REV.  
A

(R) BOLT, MACHINE - HEXAGON HEAD,  
PD SHANK, TITANIUM AMS4967 (UNS R56400),  
.190-32 UNJF-3A

**SAE AS9633**  
SHEET 1 OF 2

FIGURE 1 - BOLT

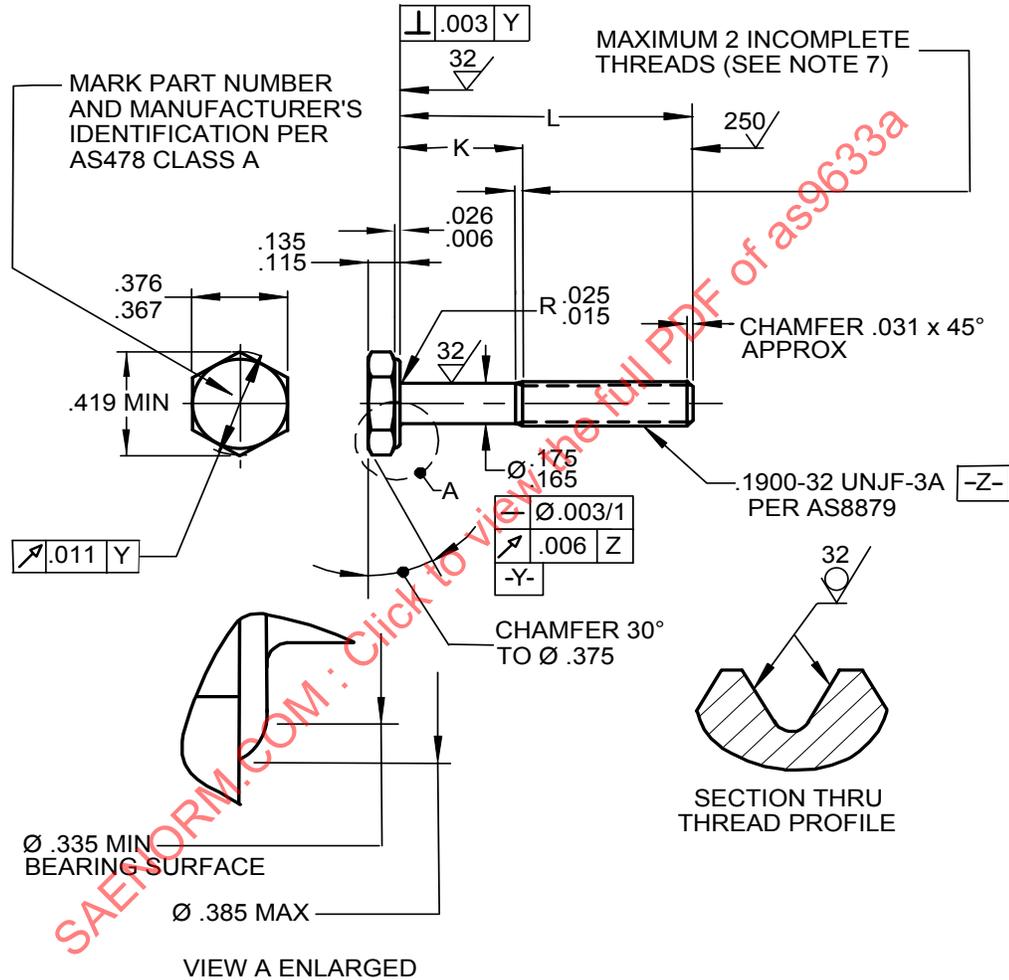
FIGURE 1 UPDATED TO ADD CORRECT THREAD SPECIFICATION AND THE CORRECT GEOMETRIC TOLERANCES. THE DOCUMENT IS UPDATED TO ADD FULL PART NUMBER MARKING.
